ADDENDUM NO. 2

PACIFIC HIGH SCHOOL – NEW ADMINISTRATION BUILDING

SAN BERNARDINO CITY UNIFIED SCHOOL DISTRICT

DSA No. 04-119637 File No. 36-H7 RCA Job No. 1-78-28

NORTH ELEVATION

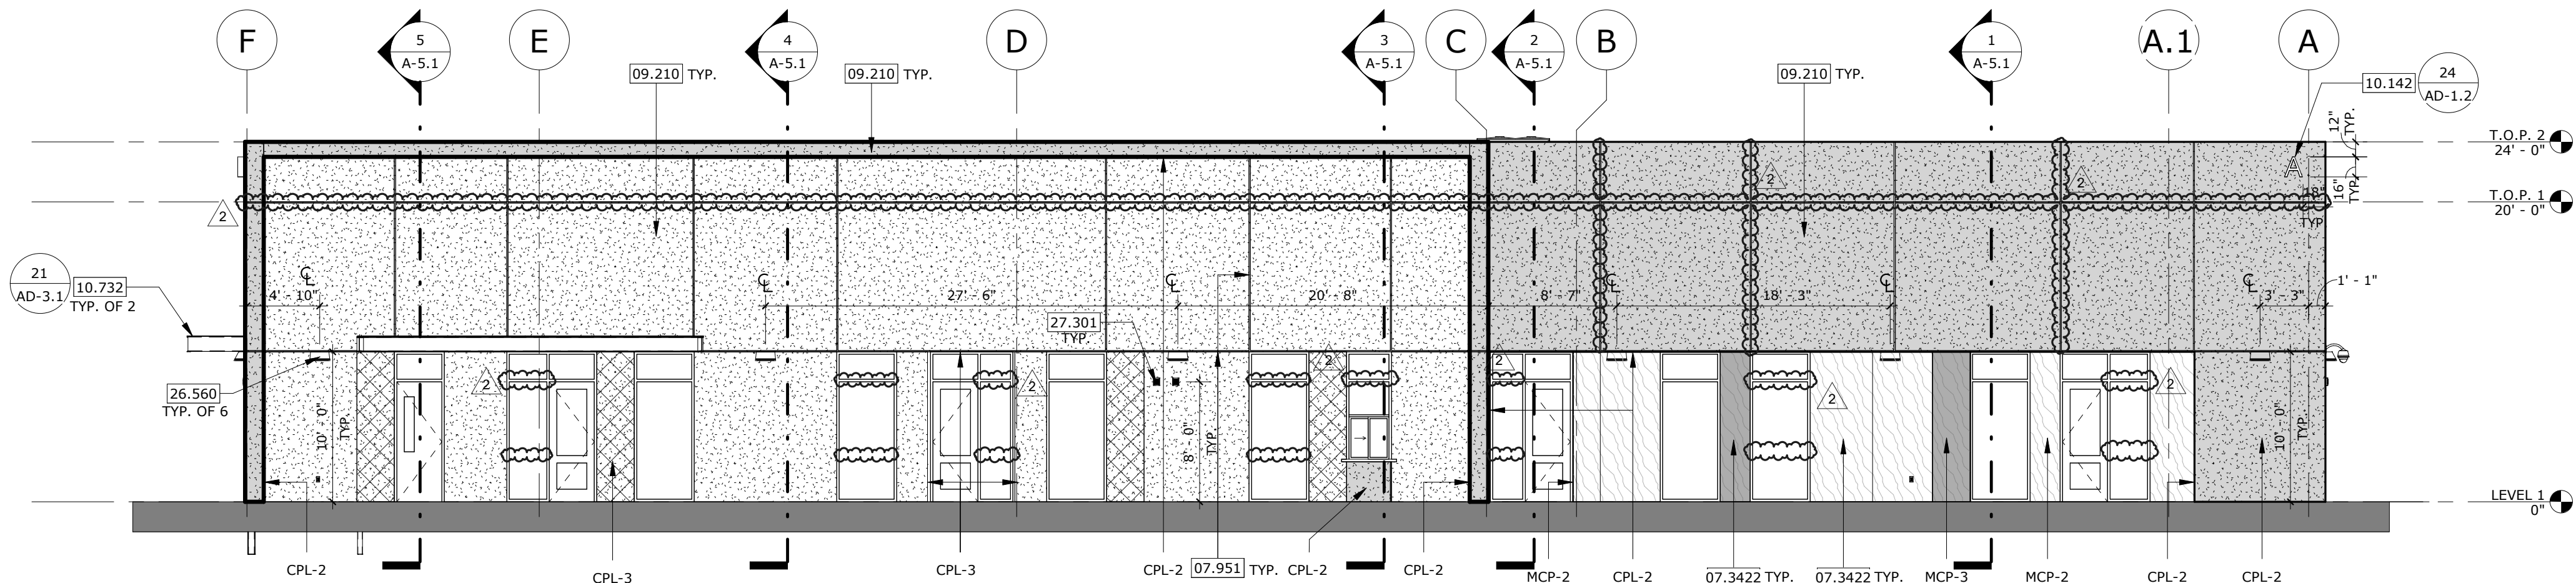
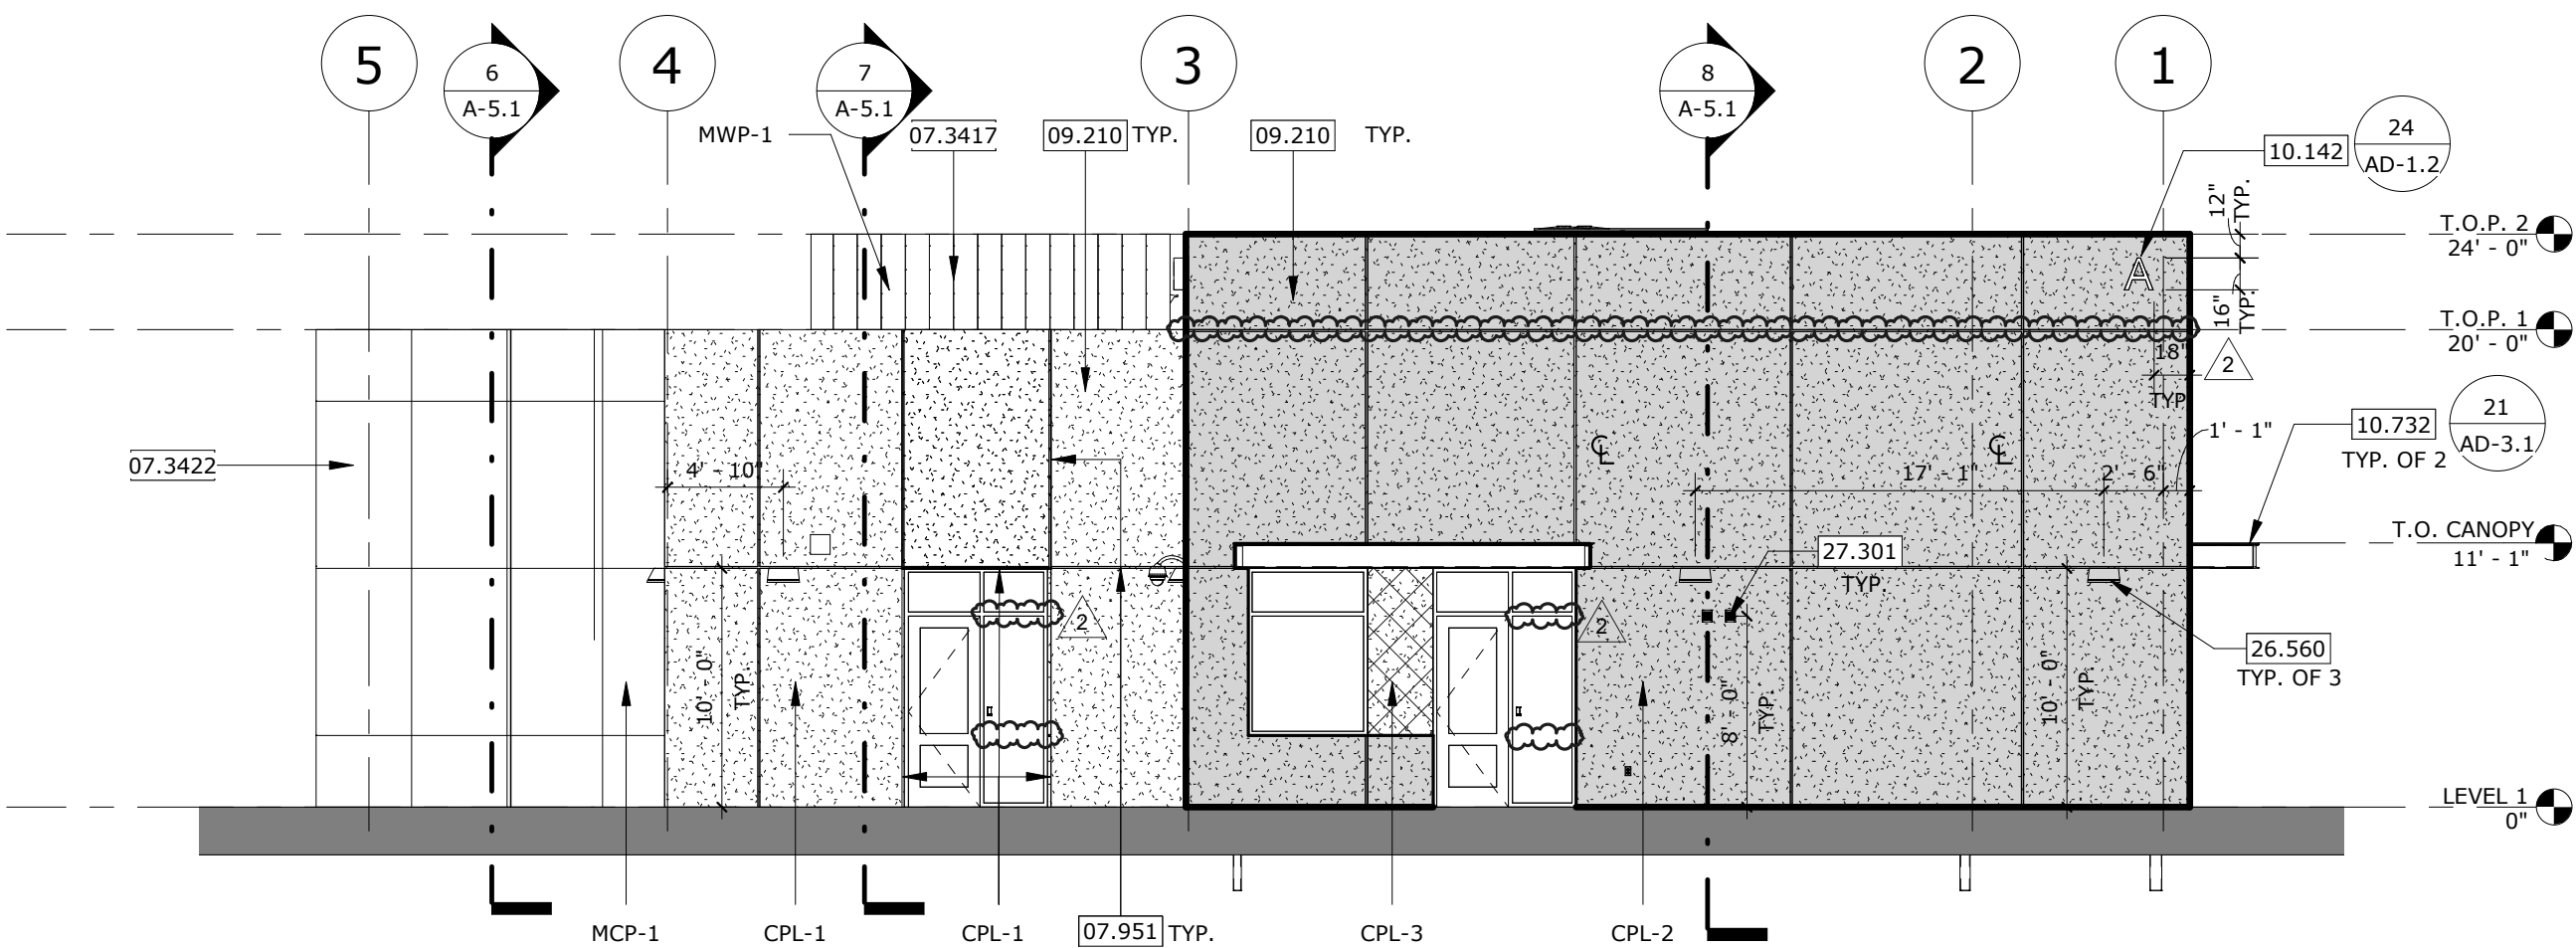
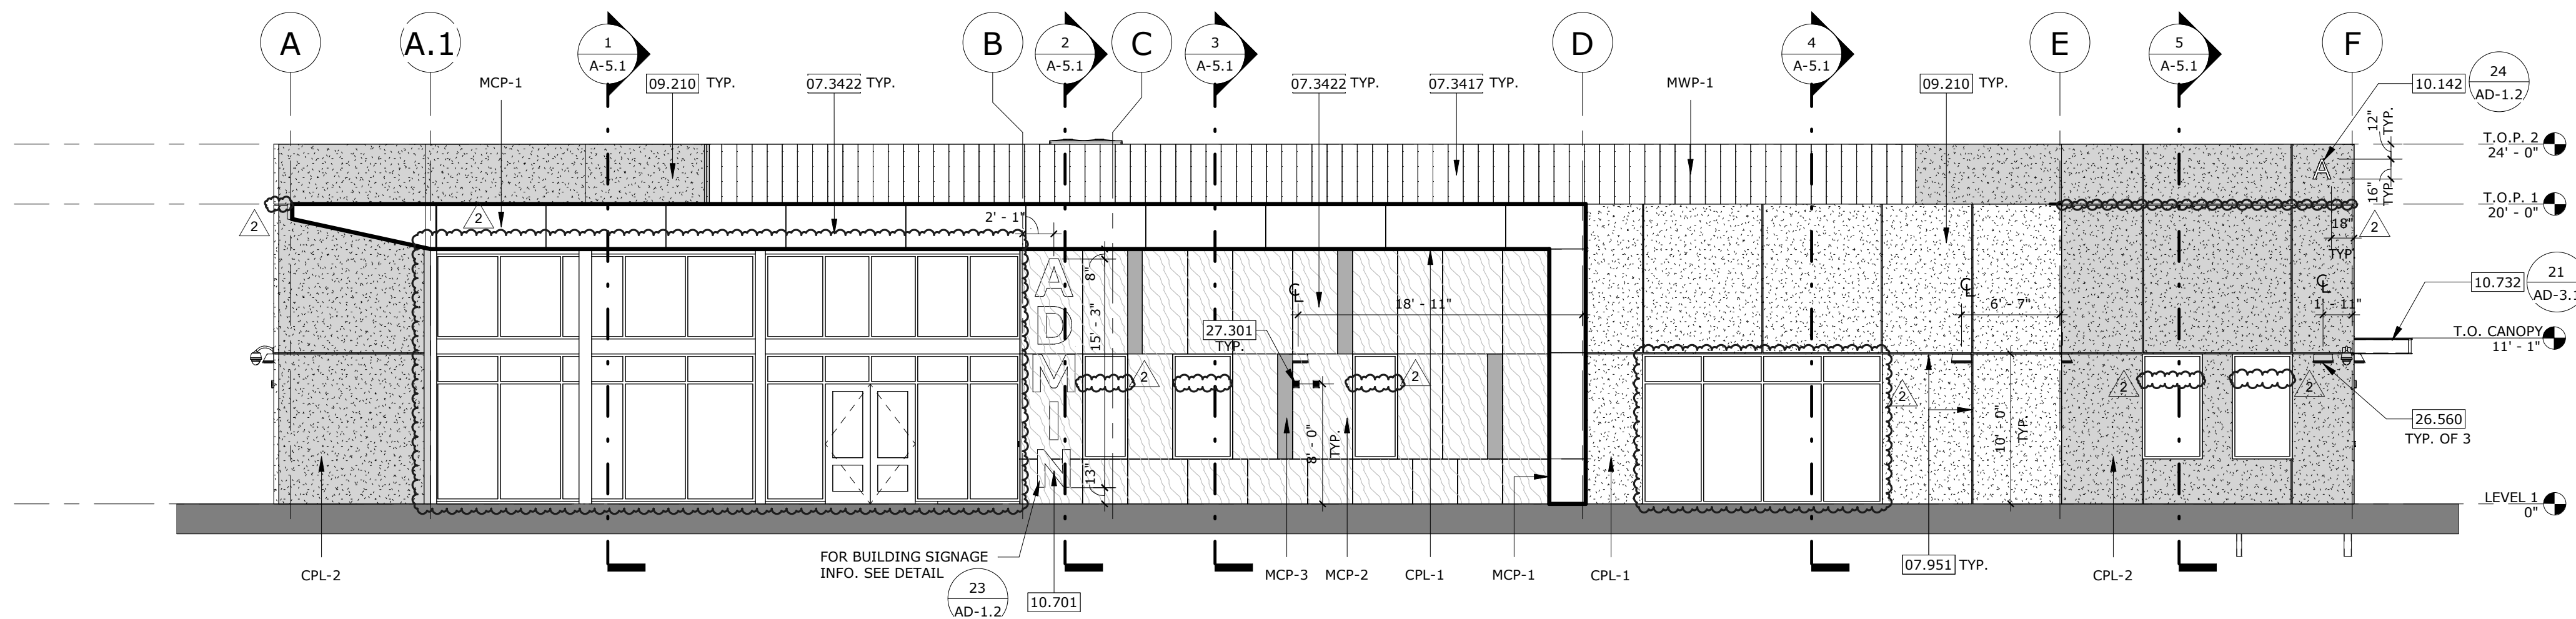
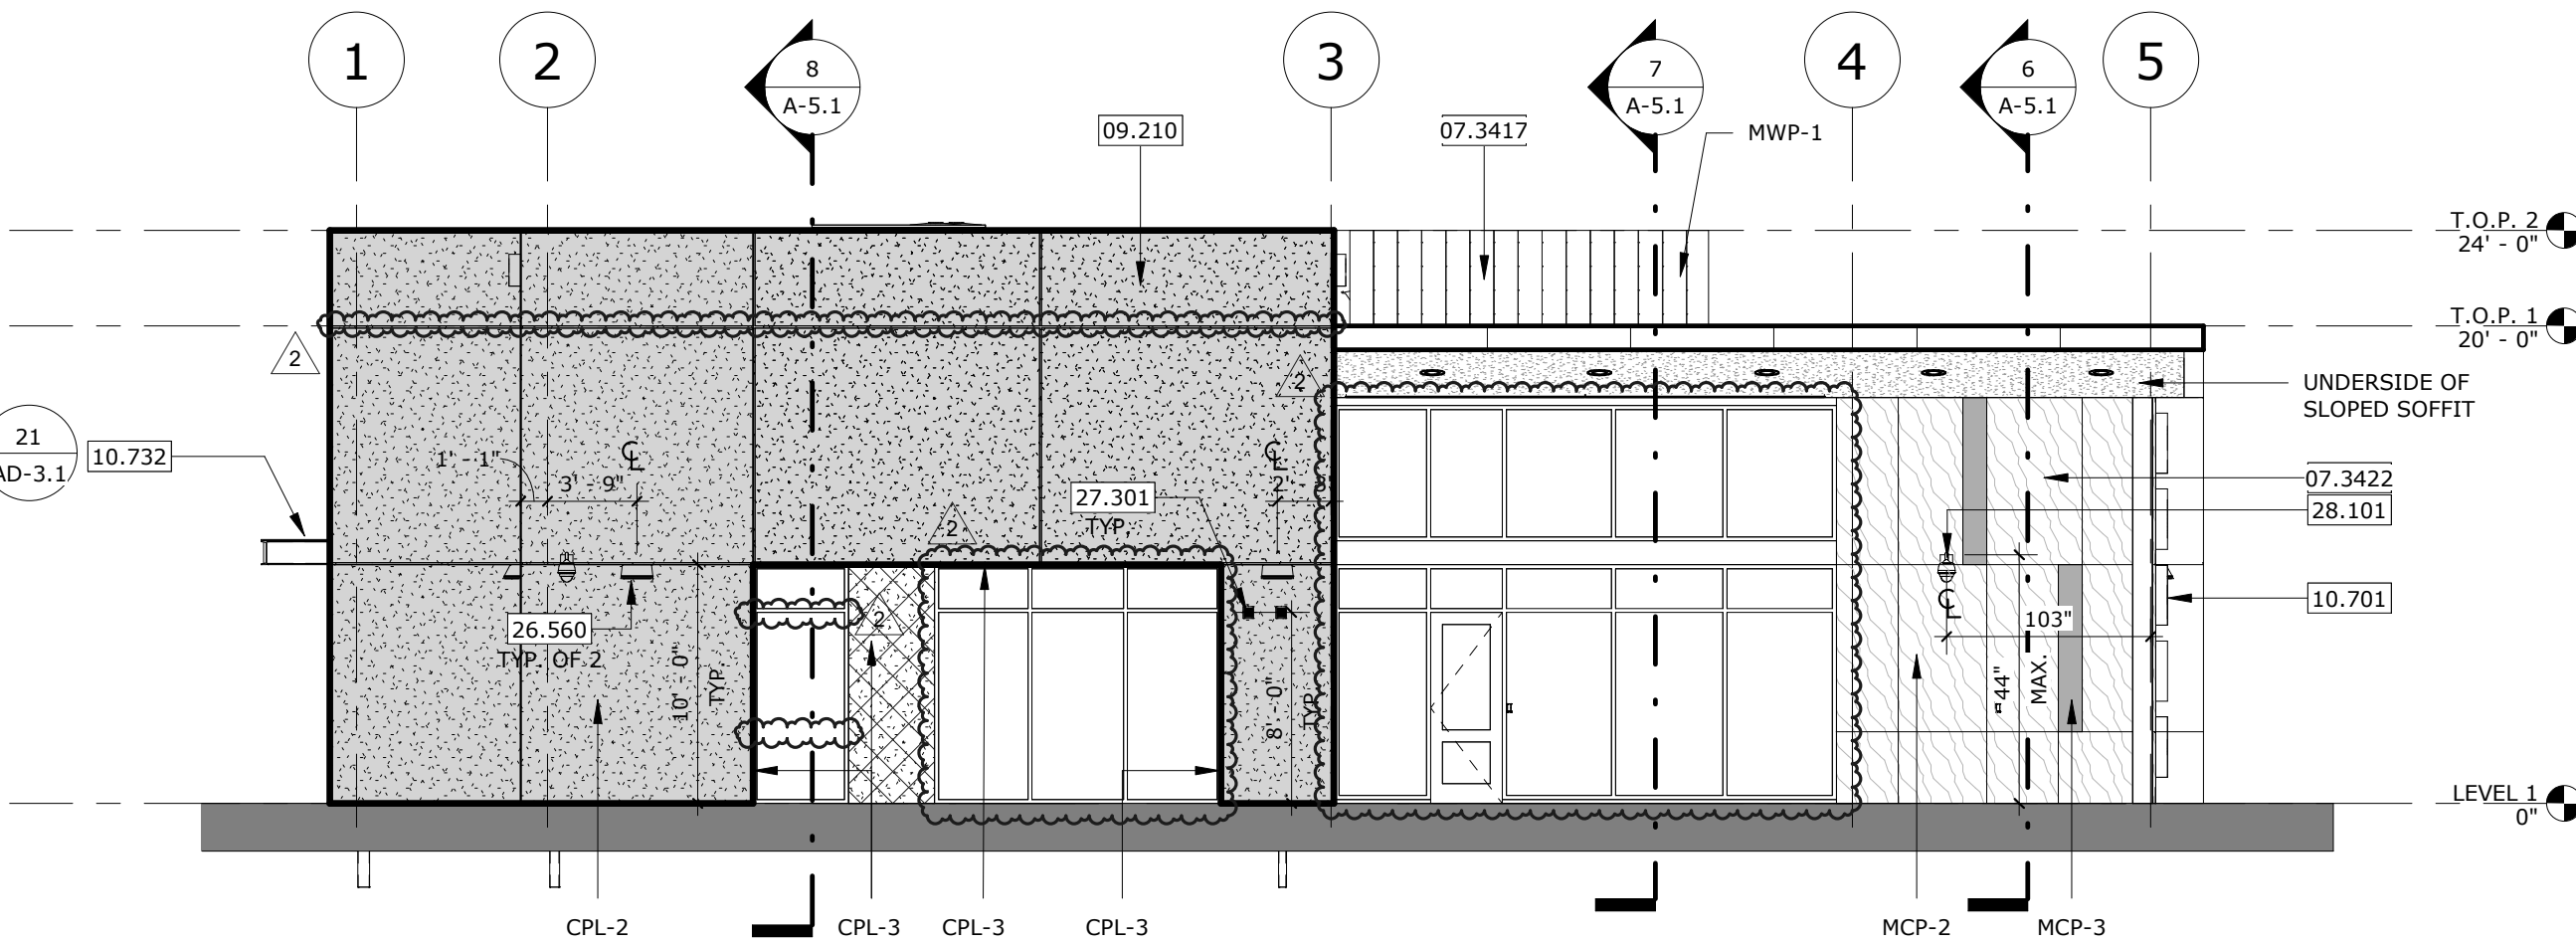
- 2.9.1 Revise per clouded area of attached Sheet A-4.1:
 - a. Revise window mullion pattern
 - b. Revise plaster control joints
- Item No. 2.10 Reference Sheet A-8.1:
